MCPB Item No.

Date: 6/25/15

# Preliminary Plan No. 120140130, Randolph Farms

Staff recommends approval of the Preliminary Plan with conditions.

Image 2 - Preliminary Plan

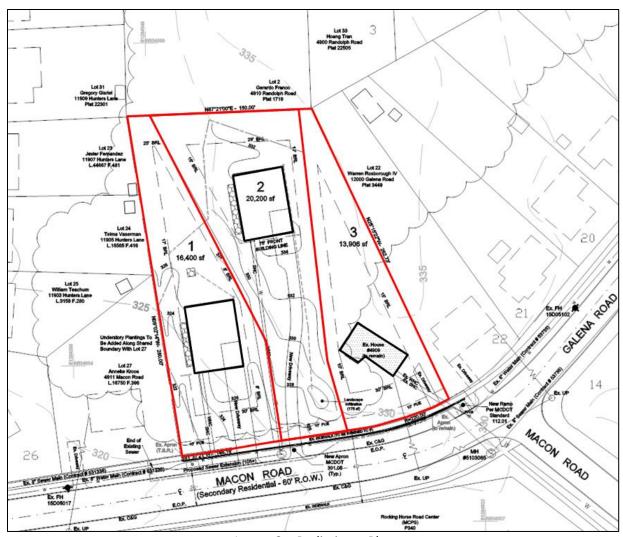
Under the R-90 Zone, the Property could have a maximum of five lots based on its size; however, the Applicant is seeking approval of a resubdivision into three lots (Attachment 1 – Preliminary Plan). The Applicant's proposal will create three lots to be served by public water and sewer, and vehicular access to each lot will be provided via individual driveways from Macon Road. Macon Road is a sixty-foot-wide right-of-way, and no additional right-of-way is required. The four-foot-wide sidewalk along the property frontage on the north side of Macon Road is required to be replaced with a five foot-wide sidewalk.

Macon Road is a 60-foot-wide Secondary Residential Street. Additional dedication of right-of-way is not required. Per the County Road Code, sidewalks are required for lots in the R-90 Zone. The Applicant is required to replace the existing 4-foot wide sidewalk along the property frontage of Macon Road with a 5-foot-wide sidewalk with a green panel and street trees. In addition, the Applicant is required to provide a receiving handicapped ramp on the northwest corner of the Macon Road-Galena Road intersection.

- c. The Final Forest Conservation Plan must include detailed and specific tree protection measures.
- 3) Prior to any use and occupancy certificate, the Applicant must replace the existing 4-foot wide sidewalk with a 5-foot-wide sidewalk with a green panel and street trees along the property frontage of Macon Road, and provide a receiving handicapped ramp on the northwest corner of the Macon Road-Galena Road intersection.

Image 3 – Variance Tree Location

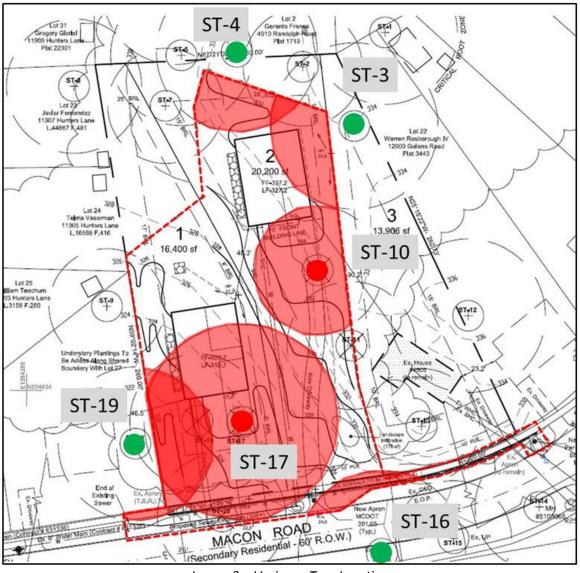
The Applicant submitted a variance request on 1/27/2014 and a revised variance request on 10/21/2015 for the impacts to trees (Attachment 3). The proposed layout will impact, but not remove, four trees and remove two trees that are considered high priority for retention under Section 22A-12 (b) (3) of the County Forest Conservation Law.

The Applicant is requesting a variance to remove two trees, ST-10, 27" mockernut hickory, and ST-17, 41" tulip poplar, for a total of 68" DBH of variance tree loss. The Applicant will mitigate for this loss by planting 1/4" caliper inch per 1"DBH lost. 17" caliper of native shade trees, using a minimum 3-inch caliper size tree, must be shown on the Final Forest Conservation Plan as mitigation for the loss of ST-10 and ST-17. If ST-19 is determined to require removal, the Applicant will further mitigate for the loss of this tree by planting an additional 8" caliper of native shade trees, using a minimum 3-inch caliper size tree. These trees must also be shown on the Final Forest Conservation Plan.

- a. The Final Forest Conservation Plan must include a total of 17" caliper of native shade trees, using a minimum 3" caliper tree, as mitigation for the loss of ST-10 and ST-17.

- b. The Final Forest Conservation Plan must include an ISA-certified arborist's evaluation and recommendations for ST-19, 32" scarlet oak. If ST-19 cannot be retained, the Applicant must amend the variance request and provide an additional 8" caliper of native shade trees, using a minimum 3" caliper tree, as mitigation for the loss of tree ST-19.

# <u>ATTACHMENT 1</u>

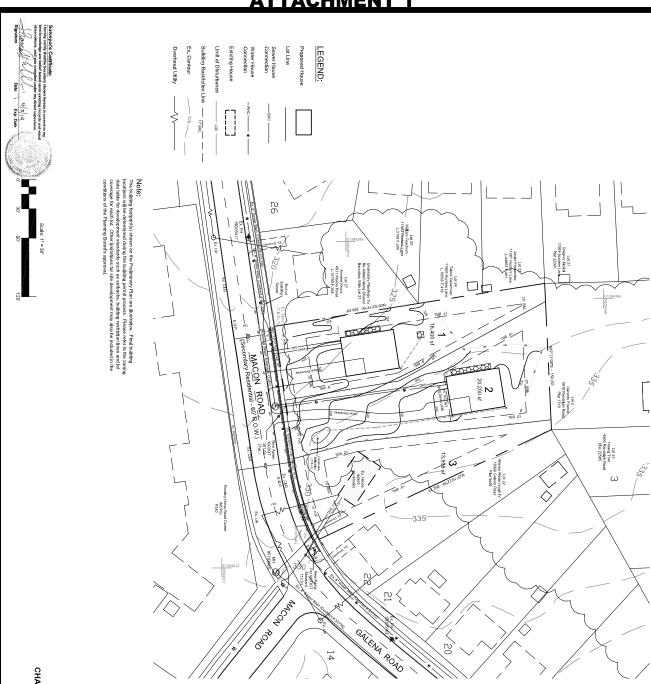
We have completed our review of the preliminary plan dated January 22, 2014. This plan was reviewed by the Development Review Committee at its meeting on March 24, 2014. We recommend approval of the plan subject to the following comments:

- 1. Grant necessary slope and drainage easements. Slope easements are to be determined by study or set at the building restriction line.
- 2. The sight distances study has been accepted. A copy of the accepted Sight Distances Evaluation certification form is enclosed for your information and reference.

- \* NOTE: the Public Utilities Easement is to be graded on a side slope not to exceed 4:1.
- A. Across the Macon Road site frontage, widen the existing sidewalk to 5 feet in accordance with current ADA standards.

- 6. You must divert as much driveway as you can on Lot 2 to the landscape infiltration.
- 7. When Lot 3 proposes future improvements you will need to address stormwater management at that time.

8. Provide a berm/swale along west side of lot one to help divert onsite drainage from going onto the adjacent lot.
